SARA reference: 2604-51886 SRA
 Council reference: CA 2025_5880/1
 Applicant reference: 2025-09-82 - Seymour Group

SARA referral agency response – 71-85 Port Douglas Road, Port Douglas

Description:	Development permit	Reconfiguring a lot (1 lot into 40 lots and common property)
	Preliminary approval	Material change of use for use rights consistent with the low-medium density residential zone and to vary the effect of the planning scheme by amending the table of assessment for short term

NOTE:
REFER DRAWING BE25041-001-DA200 FOR LEGEND.

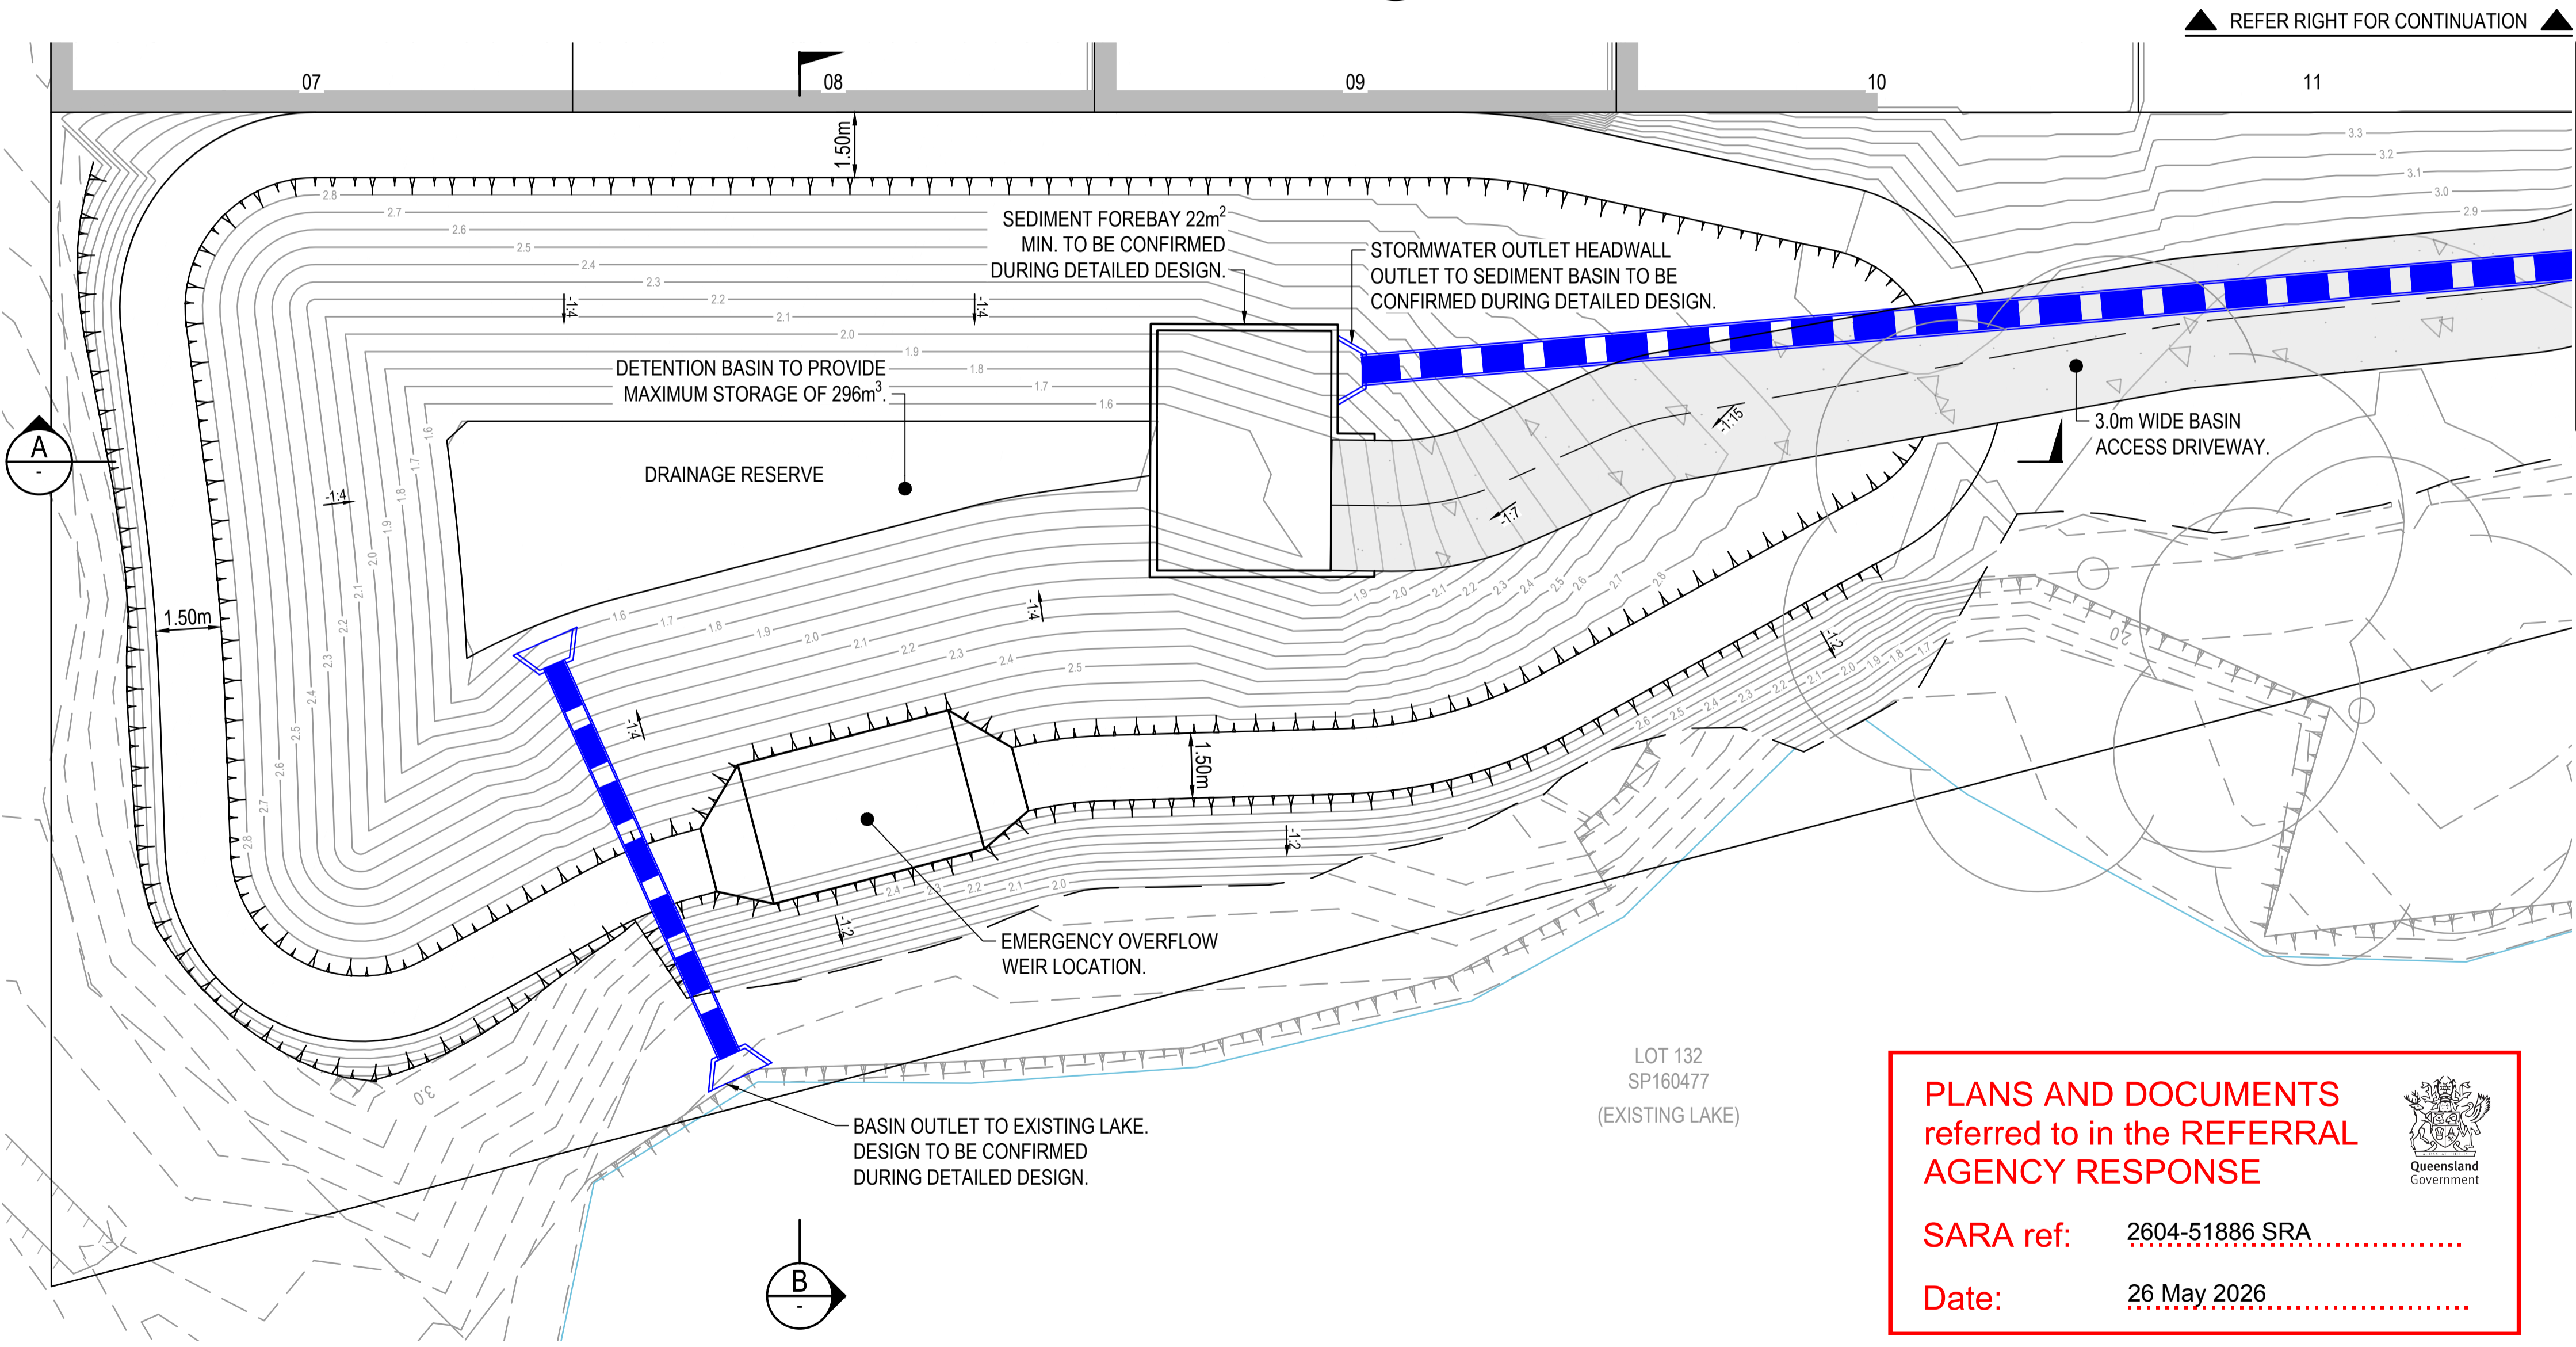
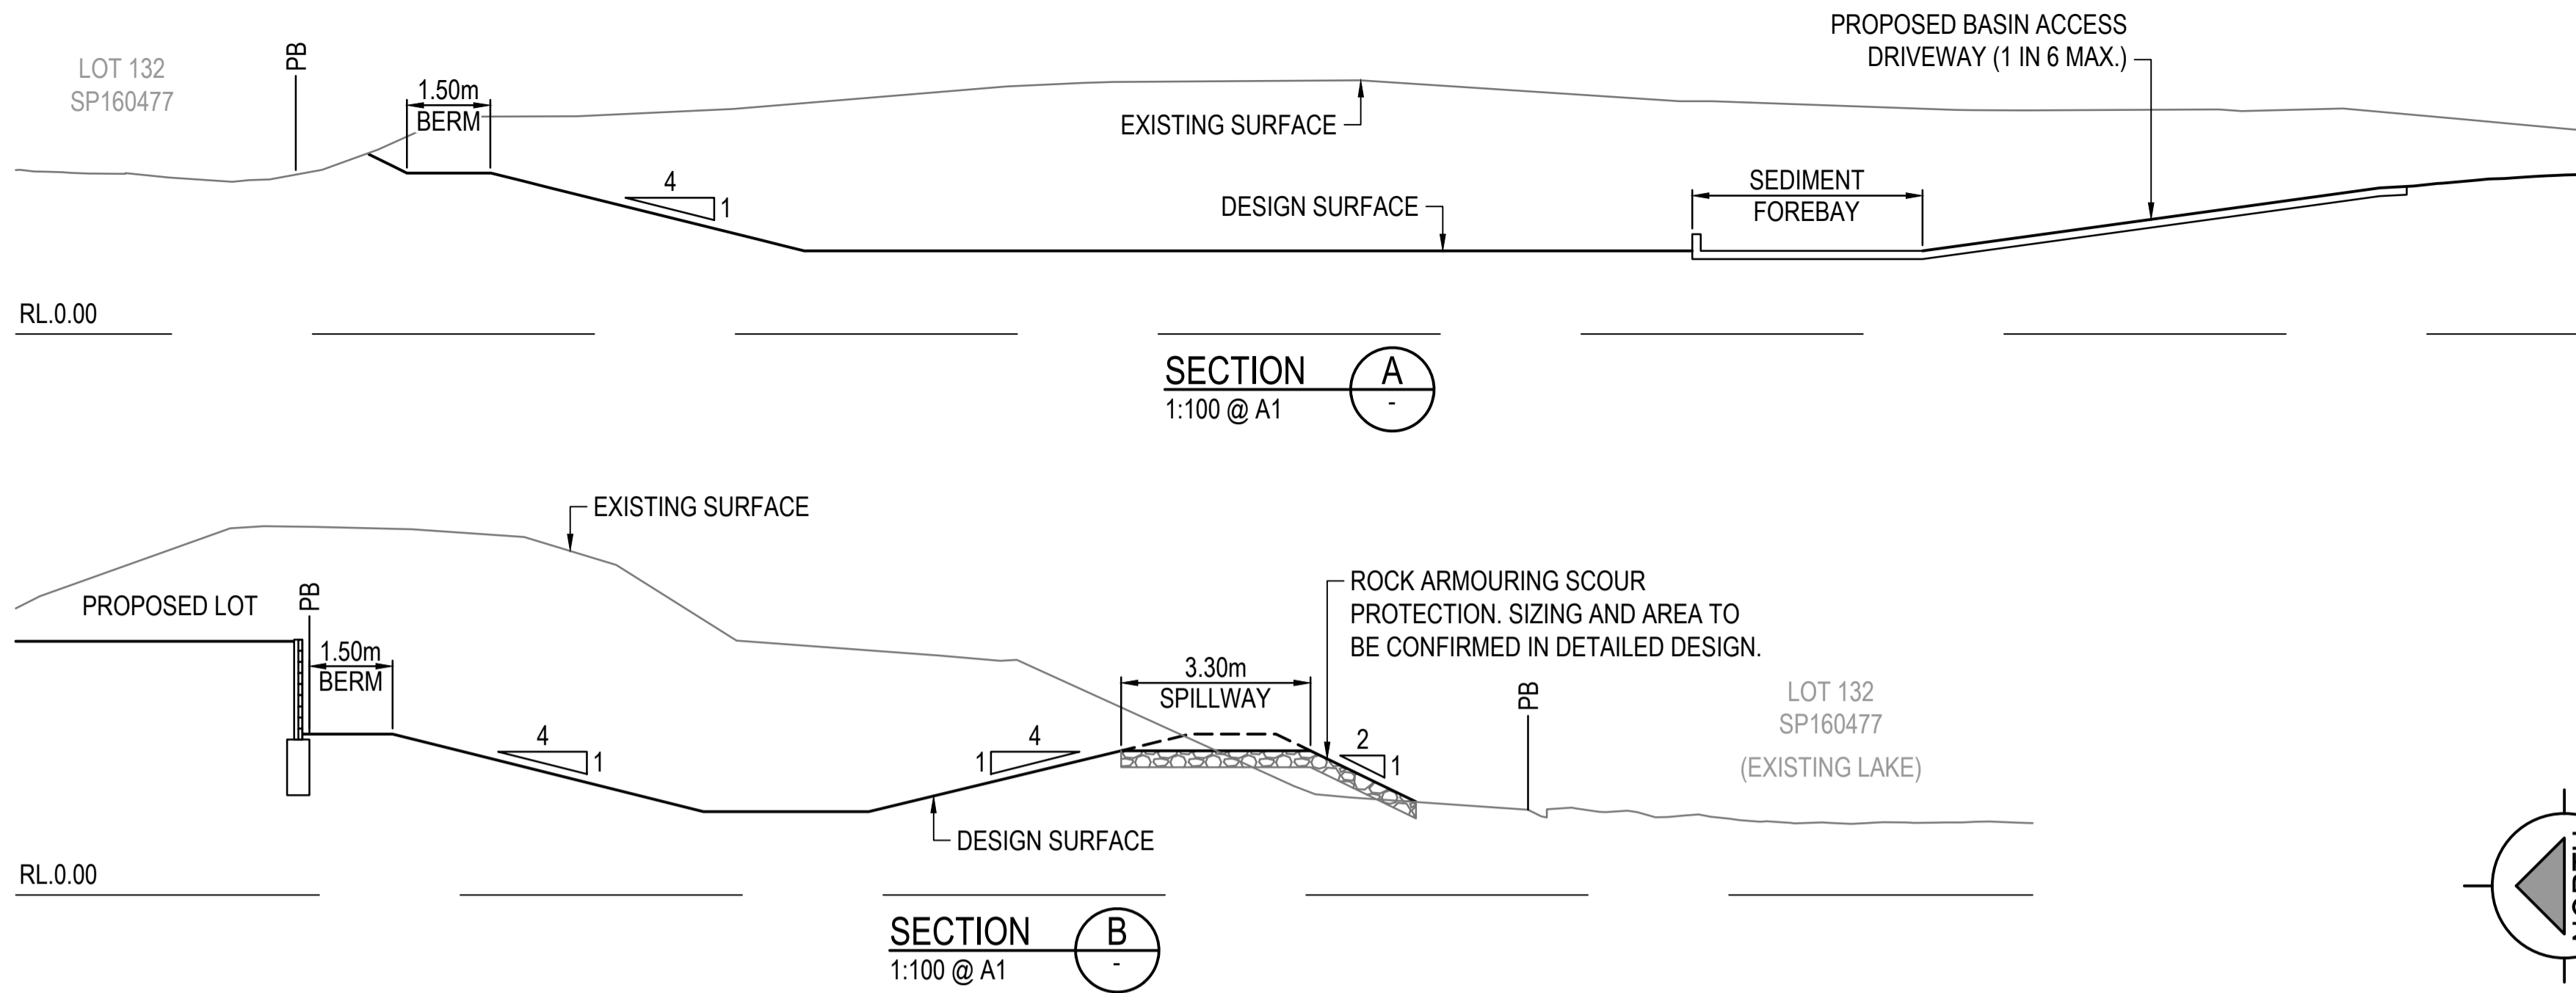
1.	<p>Stormwater infrastructure works must be undertaken generally in accordance with the following plans:</p> <p>(a) Preliminary Stormwater Drainage Catchment Plan prepared by Bourn Engineers, dated 18.12.2025, Drawing DA400, Revision 1.</p> <p>(b) Preliminary Detention Basin Layout Plan prepared by Bourn Engineers, dated 18.12.2025, Drawing DA401, Revision 1.</p>	<p>Prior to submitting the Plan of Survey to the local government for approval.</p>

Figure 7-1: Recommended Noise Barriers

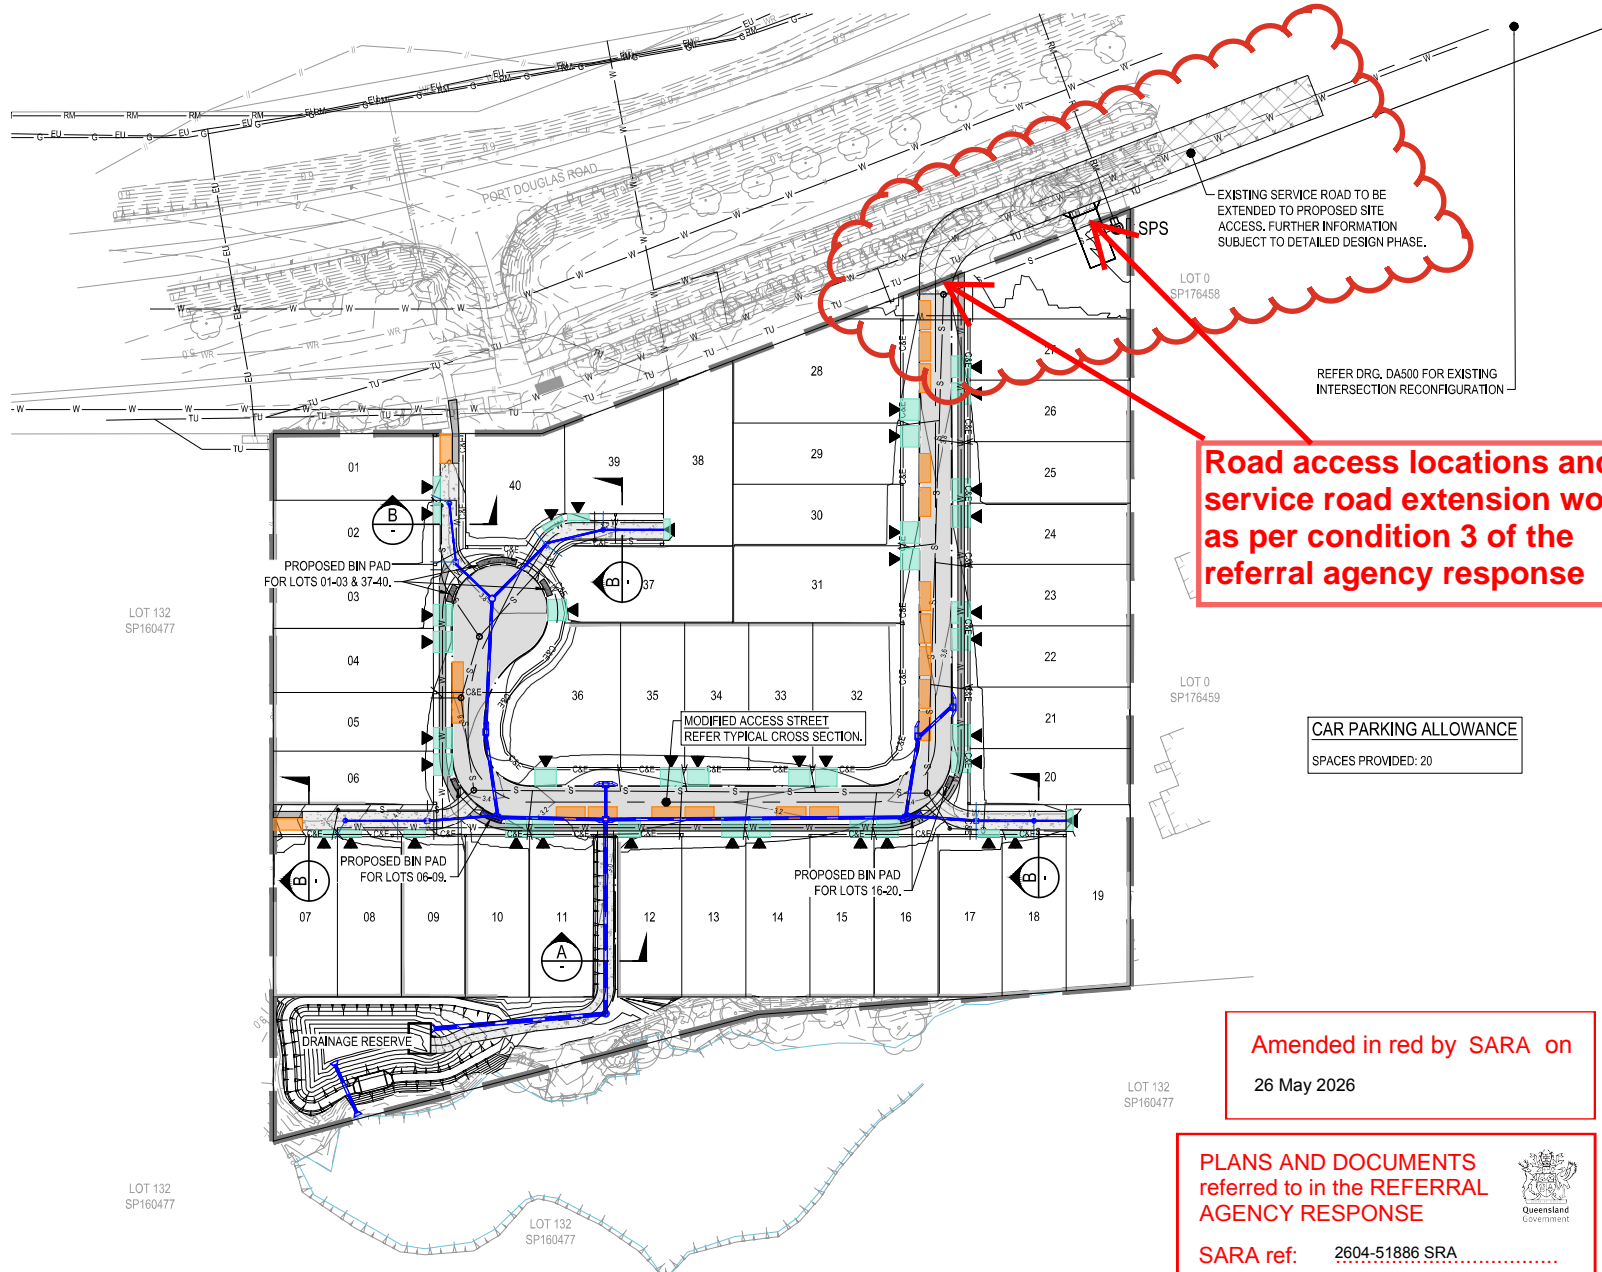
2.	<p>(a) Construct noise barriers, 1.8m and 2.0m in height including returns, at the locations shown in Figure 7-1 Recommended Noise Barriers (Map 7) of the Road Traffic Noise Intrusion Assessment Report prepared by SLR, dated 19 December 2025, Reference 620.042901.00001 and Revision 1.0.</p> <p>(b) Design the noise barrier generally in accordance with:</p> <ul style="list-style-type: none"> • Section 7.2 Noise Barriers and Section 8.0 Conclusion of the Road Traffic Noise Intrusion Assessment Report prepared by SLR, dated 19 December 2025, Reference 620.042901.00001 and Revision 1.0 and the following standards: <ul style="list-style-type: none"> o the Department of Transport and Main Roads' Road Traffic Noise Management Code of Practice, Volume 1, Chapter 7 and technical Specification MRTS15; o the Department of Transport and Main Roads' technical Specifications MRTS15 Noise Fences (as amended by QR-CTS-Part 41); and o the Department of Transport and Main Roads' Standard Drawings. <p>(c) RPEQ certification must be provided to Cairns Corridor Management Unit (Far.North.Queensland.IDAS@tmr.qld.gov.au) within the Department of Transport and Main Roads, confirming that the development has been constructed in accordance with parts (a) and (b) of this condition.</p>	<p>(a) – (c): Prior to submitting the Plan of Survey to the local government for approval and to be maintained at all times.</p>
